**RIVERDALE CITY PLANNING COMMISSION AGENDA
CIVIC CENTER - 4600 S. WEBER RIVER DR.
TUESDAY – JANUARY 26, 2020**

SUBJECT: Consideration of Preliminary Subdivision Plat and Site Plan approval of Riverdale Center VI Subdivision, property located approximately 4163-4177 South Riverdale Road, Riverdale, Utah 84405, as requested by Anderson Wahlen & Associates, Inc and Riverdale Center North, LLC.

Preliminary Subdivision and Site Plan Review – Riverdale Center VI (Riverdale Center North, LLC), 4177, 4171, and 4163 South Riverdale Road

Attn: Mike Eggett, Community Development Director/RDA Deputy Executive Director
Proj: **Riverdale Center VI**
Subj: Plat – Preliminary Plan Review and Improvement Drawings Review

ANDERSON WALLEN & ASSOCIATES 2010 Westwood Avenue, Suite 200, Salt Lake City, Utah 84119 (801) 521-4222 • www.annawall.com	
Utility Plan Riverdale Center VI Retail - Phase 1 41725 Riverdale Blvd Riverdale, Utah	
11 Jan, 2021 SHEET NO. C3.1

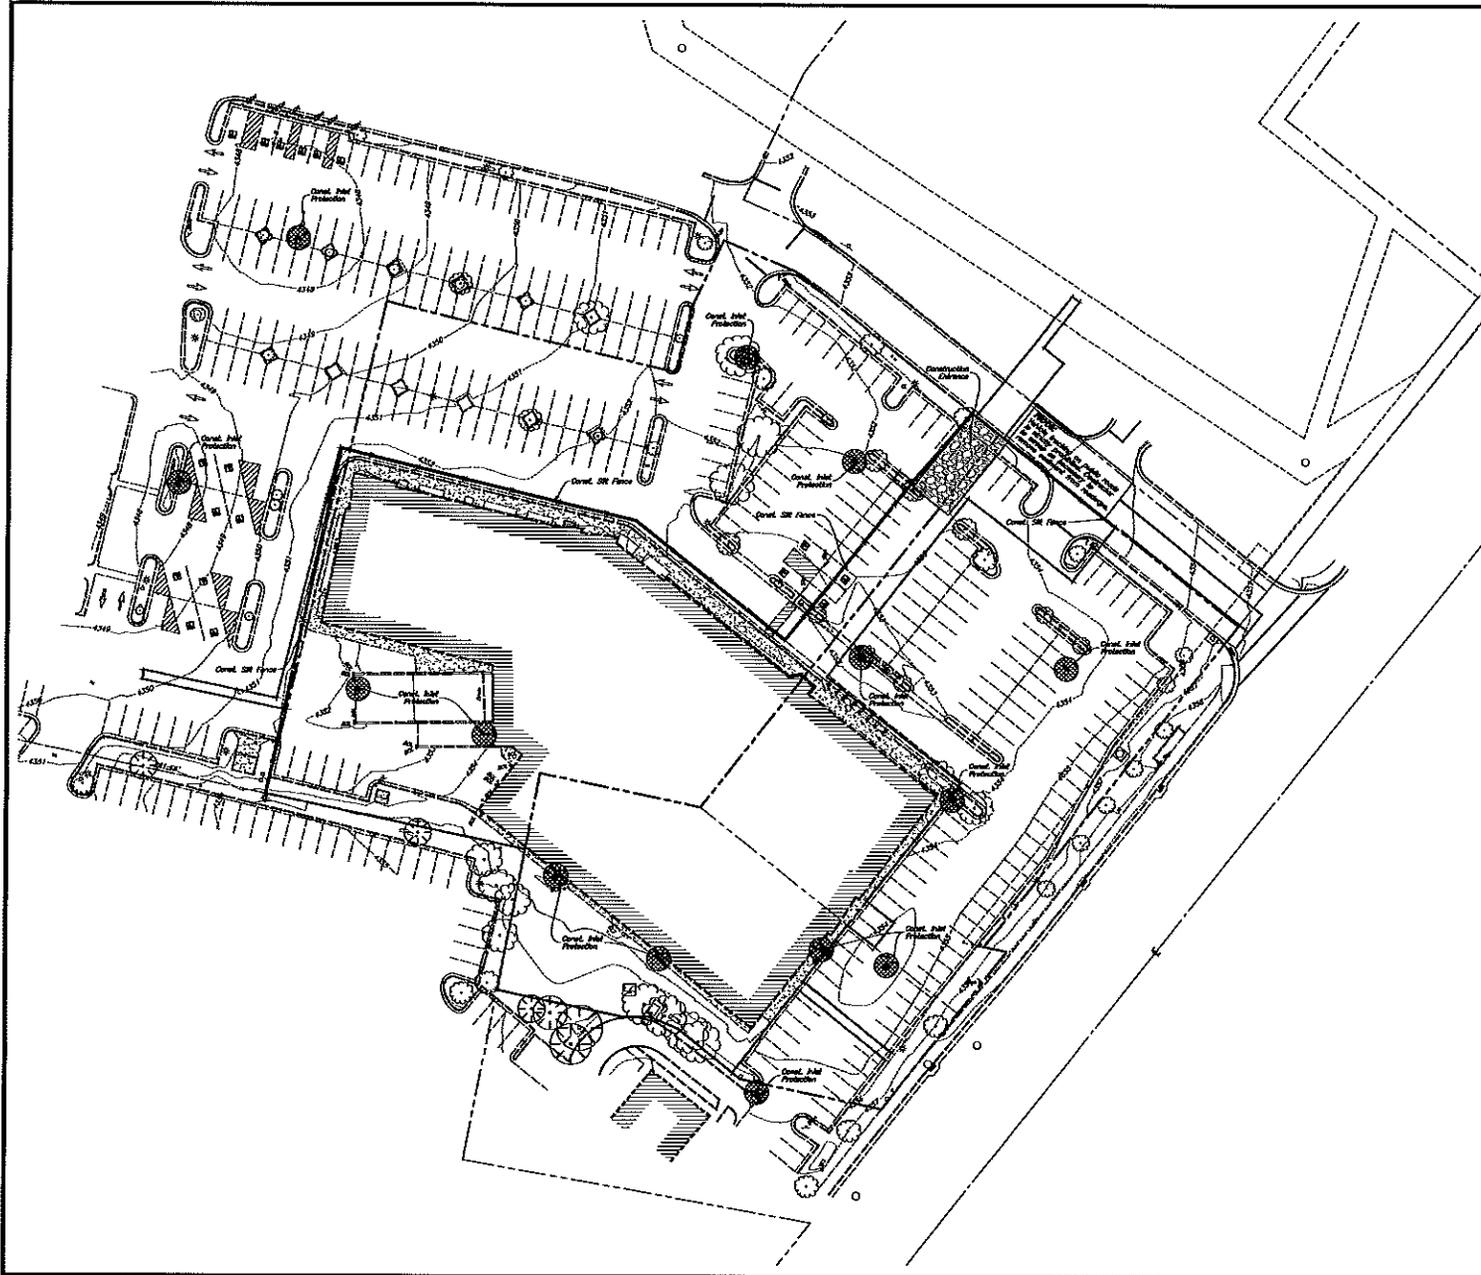
6. On drawing C3.1: Utility Plan -

- The drawing “Note” that is referring to the culinary water piping system, will need to be updated to reflect the Riverdale City standards for the C-900 pvc piping, with a class strength of DR-18, 235 psi rated pipe called-out.
- All inlet storm water boxes to be “hooded boxes”.
